The City of San Diego

Staff Report

SUBJECT: Consideration of Alternate Methods and Materials Application PRJ-1165197 for 3450 El Cajon Boulevard – (PRJ-1077714)

CONSTRUCTION TOLERANCES
CODE MODIFICATION
EQUIVALENT FACILITATION
ALTERNATE MEANS AND METHODS
CORRIDOR WIDTH
FEATURES FOR PERSONS WITH DISABILITIES
2019 CALIFORNIA BUILDING CODE

T2.1

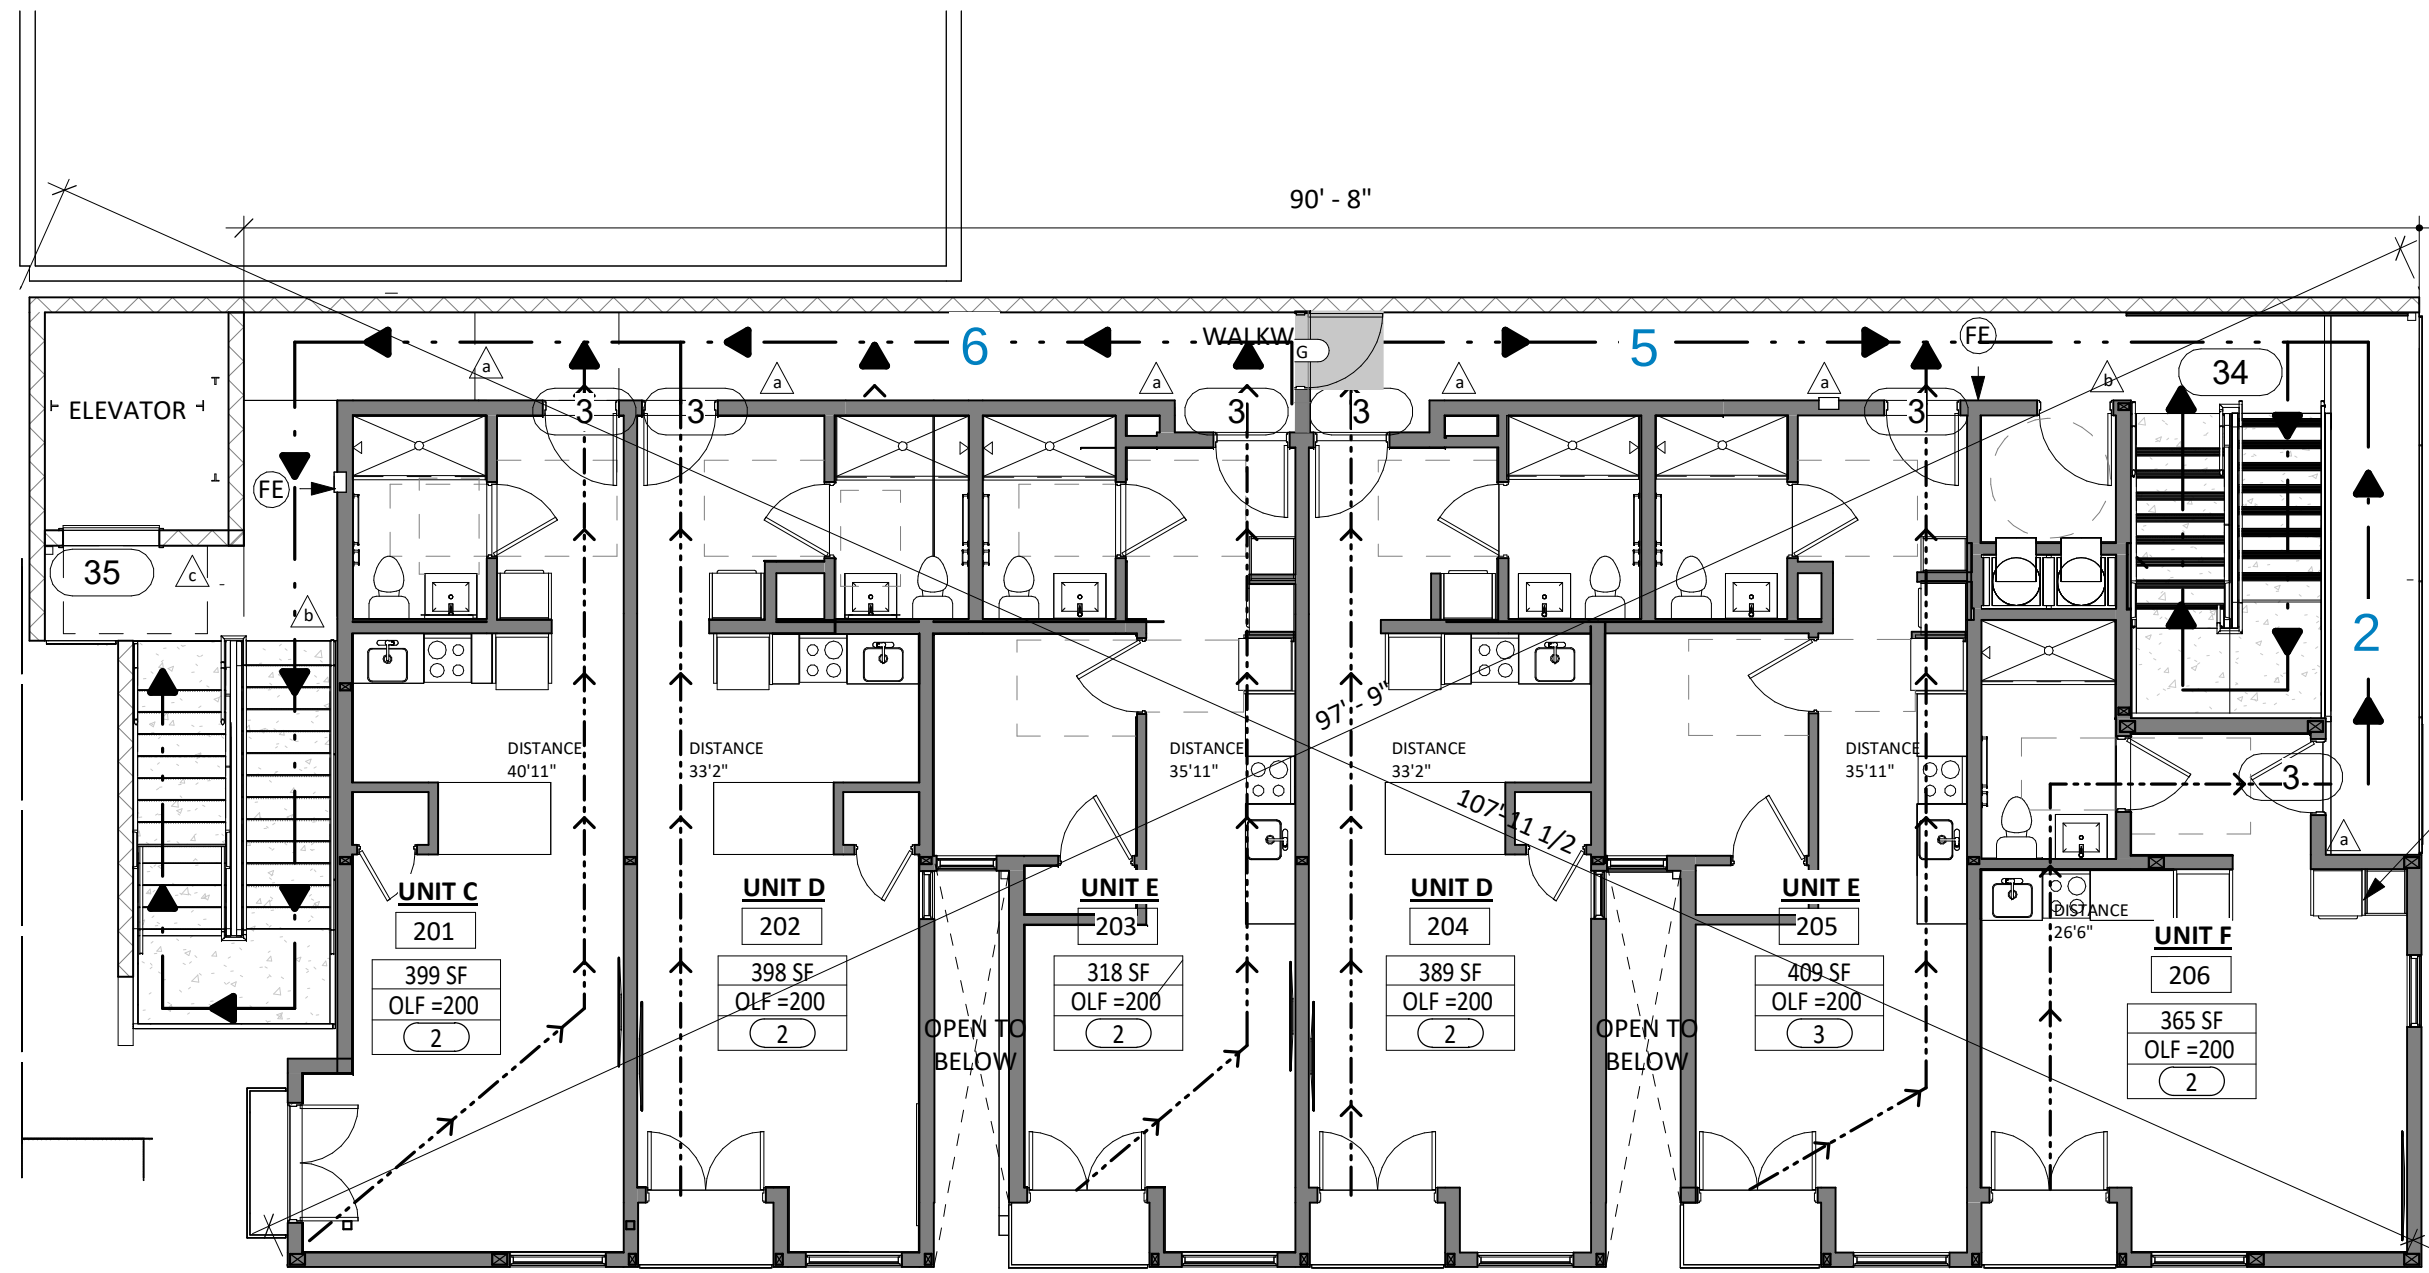
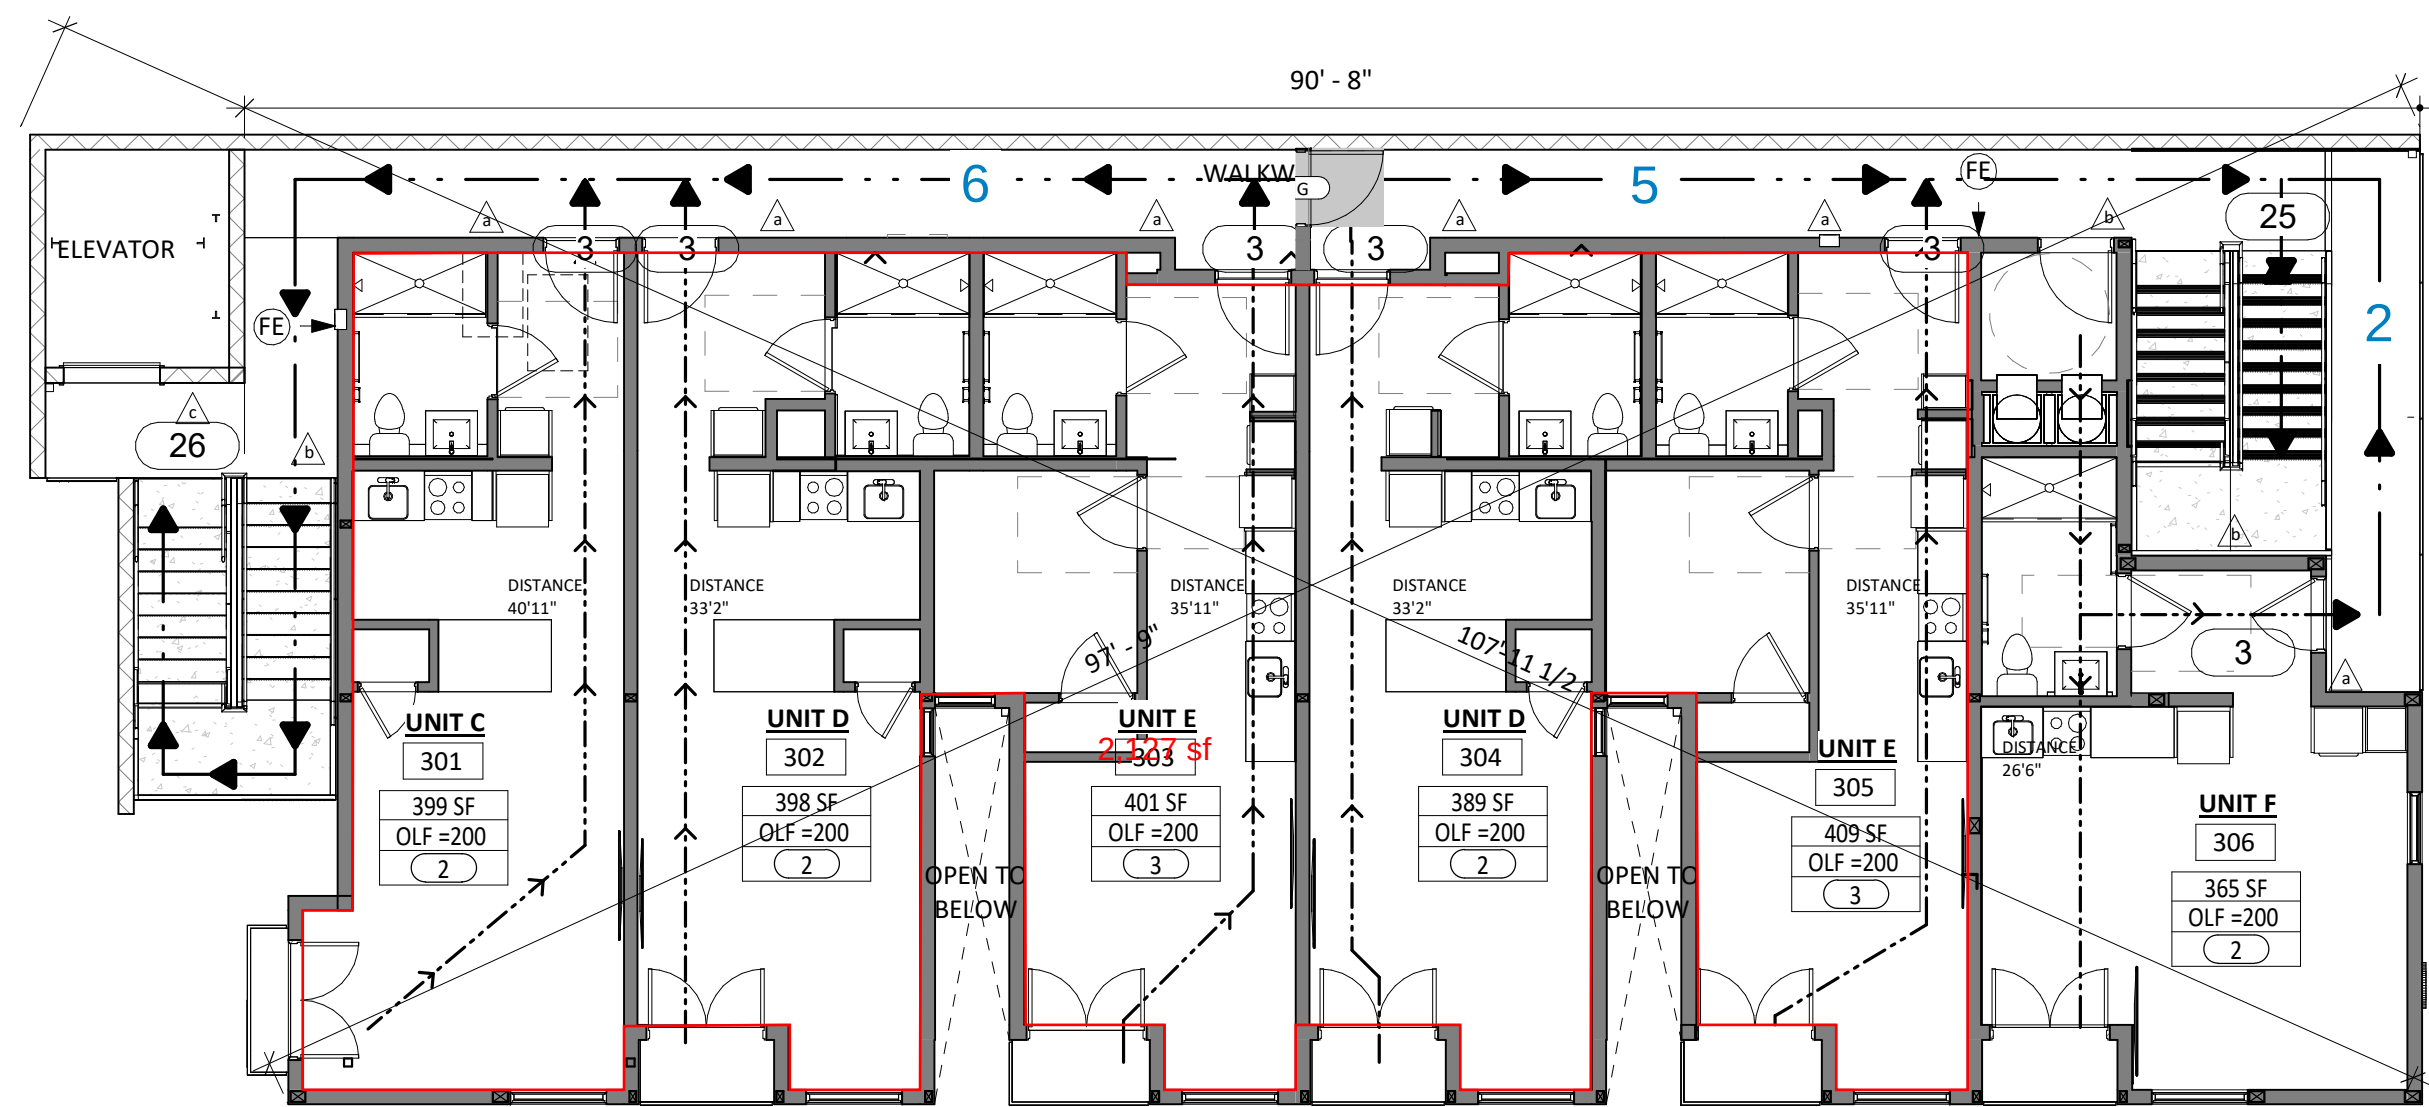
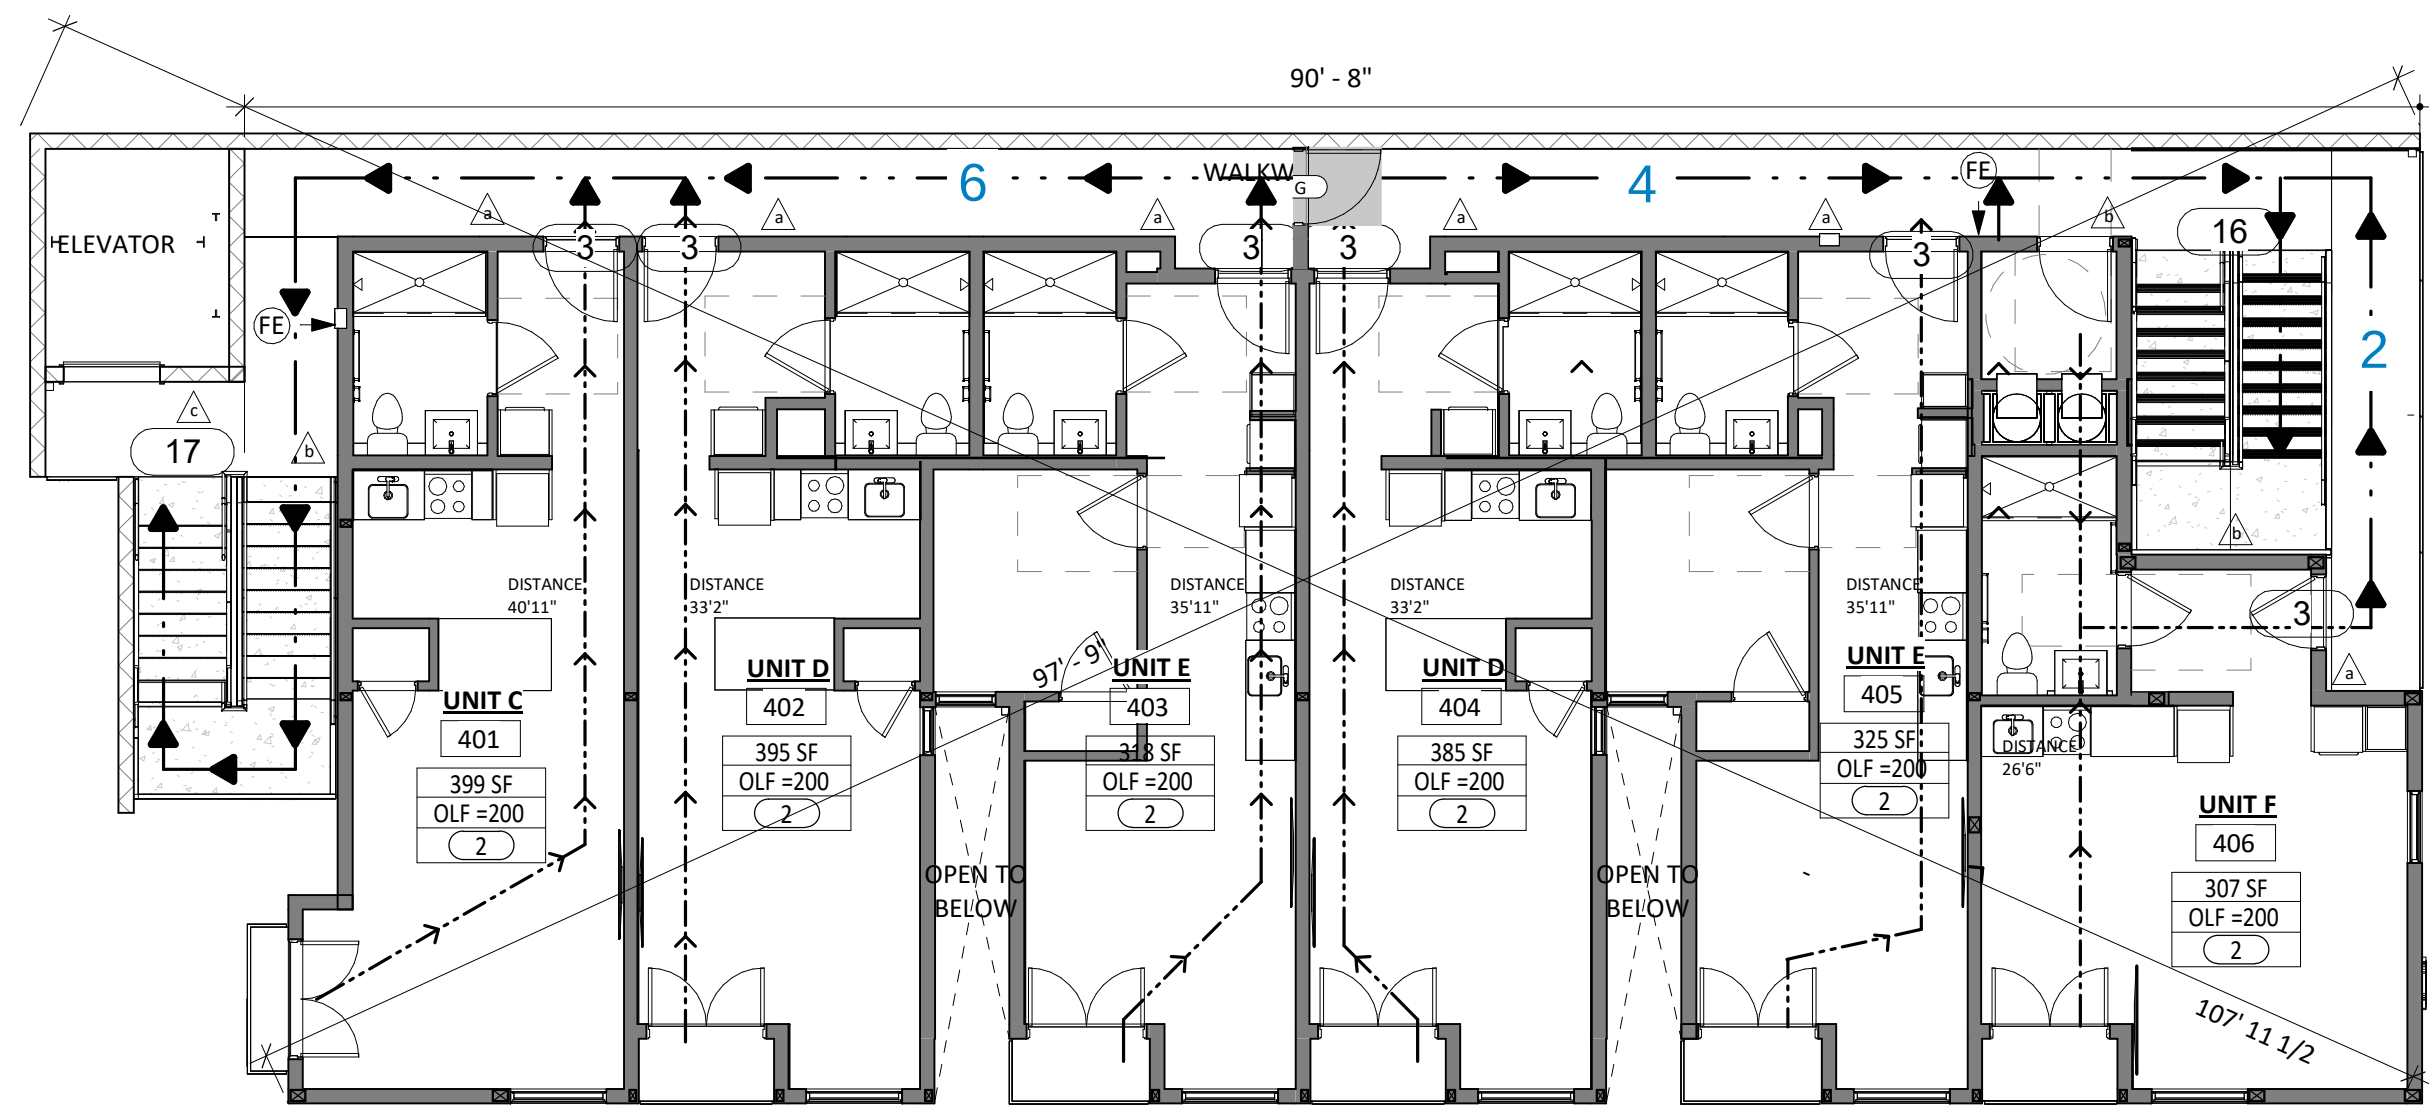
As shown on the approved plans for the means of egress,²⁰ the maximum occupant load is 7 persons in each of the separate corridors on either side of the horizontal exit towards the stairways. As such, these separate corridors must be at least 36 inches wide. As-built construction complies with this requirement.

²⁰ Architectural Drawings, Sheets T2.1, T2.2 – see modified attachment at end of this report.
